<p><b>PROPRIETARY &amp; CONFIDENTIAL</b> INFORMATION CONTAINED IN THIS DRAWING IS THE SOLE PROPERTY OF MAC Company. ANY REPRODUCTION IN PART OR AS A WHOLE WITHOUT WRITTEN PERMISSION IS PROHIBITED.</p> <p><b>THIS DOCUMENT IS UNCONTROLLED WHEN PRINTED.</b> BEFORE USE, CHECK ELECTRONIC COPY TO VERIFY THAT THIS IS THE CURRENT VERSION</p>	<p>Third Angle Projection</p>	<p><b>UNLESS OTHERWISE SPECIFIED</b> Dimensions are in Inches Dimensions in [ ] are in mm</p>	<p><b>INCH TOLERANCES:</b> TWO DECIMAL ±.03 THREE DECIMAL ±.005 ANGULAR ±1°</p>	<p><b>MAC COMPANY</b> 1740 Main Ave W   Suite F West Fargo, ND 58078 701.203.3811   888.293.5666 www.maccompany.com</p>
	<p>DRAWN BY: Jeff Stein</p>	<p>DATE: (mm/dd/yyyy)</p>	<p>SHEET SCALE 1:8 SHEET SIZE B</p>	<p>VENDOR PART NUMBER:</p>
<p>REVISION: B</p>	<p>DO NOT SCALE DRAWING</p>	<p>WEIGHT: (LB)</p>	<p>SHEET 1 OF 1</p>	<p>PART NUMBER: <b>003057P1</b></p>

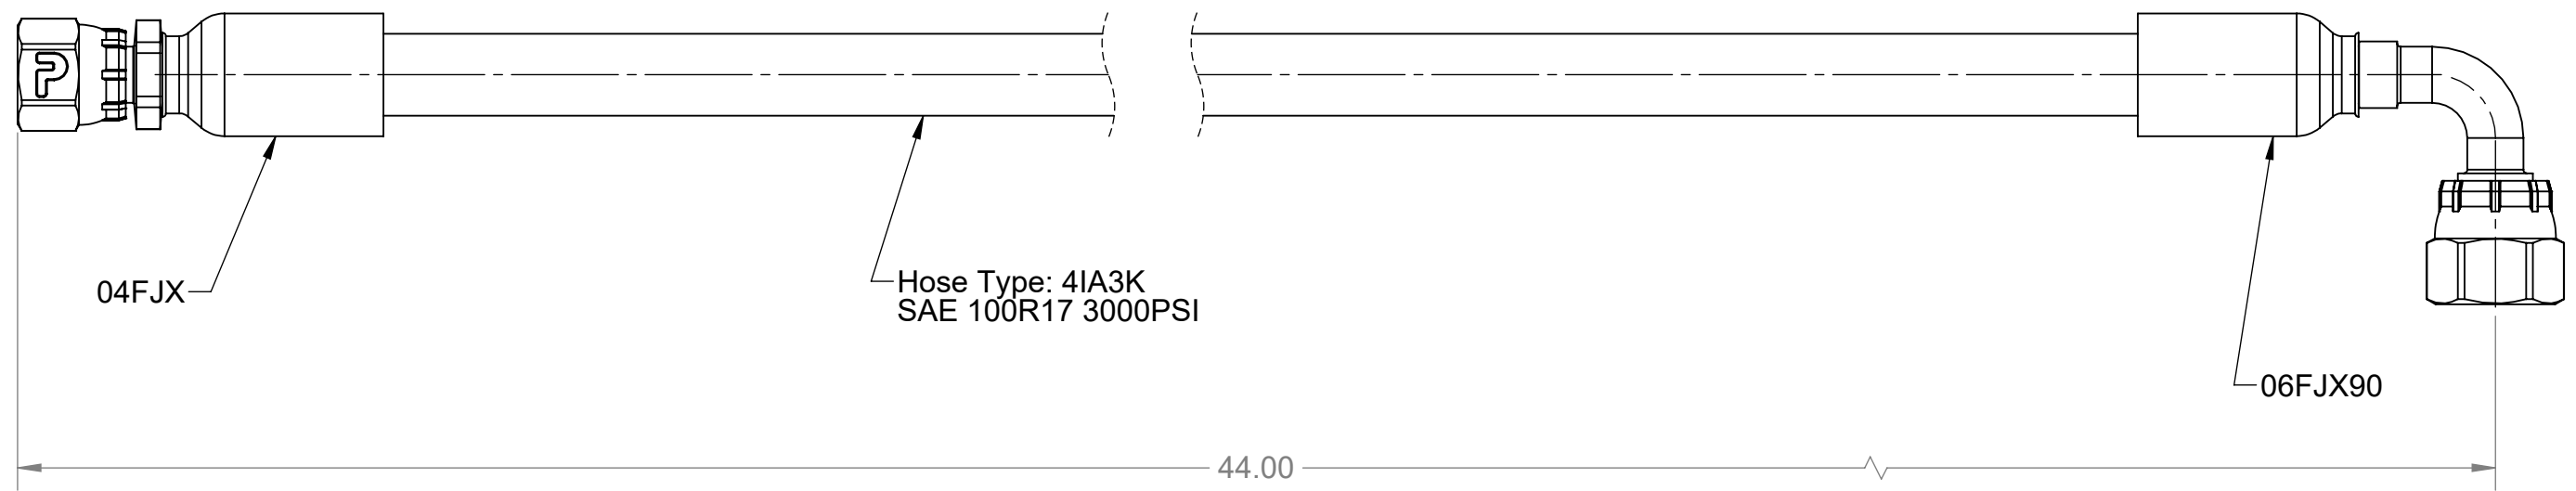
6/8/2023	B	Changed from 06 to 04 hose, subtracted 2" from length, changed from 06FJX to 04FJX, and 06FJX 90 to 04-06FJX90	JKS
5/16/2023	A	Released	JKS
DATE (mm/dd/yyyy)	REV	CHANGE RECORD	BY
